SERVICE BULLETIN

APPLICABILITY: 2020-23MY Legacy & Outback
2023MY Ascent

NUMBER: 07-213-22R

SUBJECT: Genuine Battery Replacement

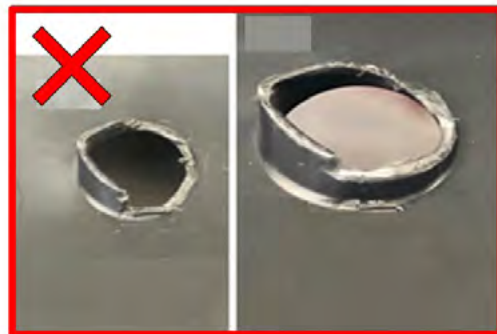
A. CAREFULLY cut off and trim the two protrusions on the bottom of the battery tray. This will allow a proper fit when installed. Try to make the cut as flush as possible.

CAUTION: Be sure the protrusions are trimmed flush. The remaining protrusion height **MUST** be less than 2mm to provide proper fitment.

Remaining Height Is Less Than 2mm

Remaining Height Is More Than 2mm

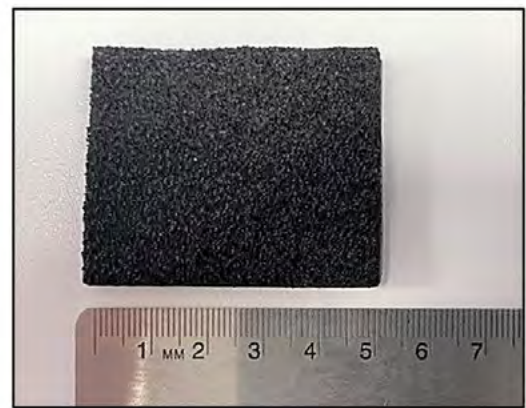
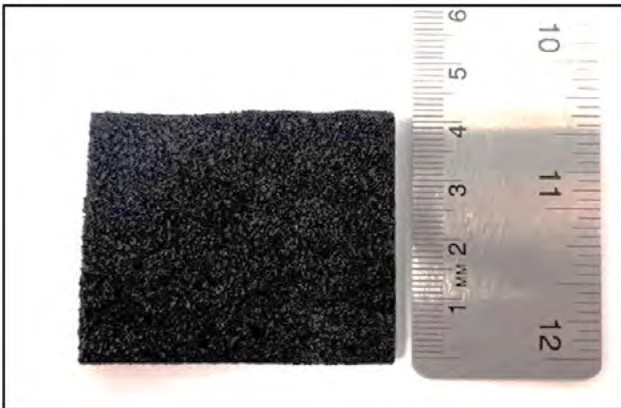
- B.** Remove and the original battery tray. **DO NOT** discard as this must be returned to the customer.

- C.** Prepare two pieces of EPDM neoprene sponge strip. Cut the sections approximately 40 mm tall and 50 mm wide. EPDM Neoprene SBR Strip (item # 6YHD7) supplied by Grainger was used in the example photos below.

- D.** Cover the newly made holes with the two previously prepared EPDM neoprene sponge strip pieces.
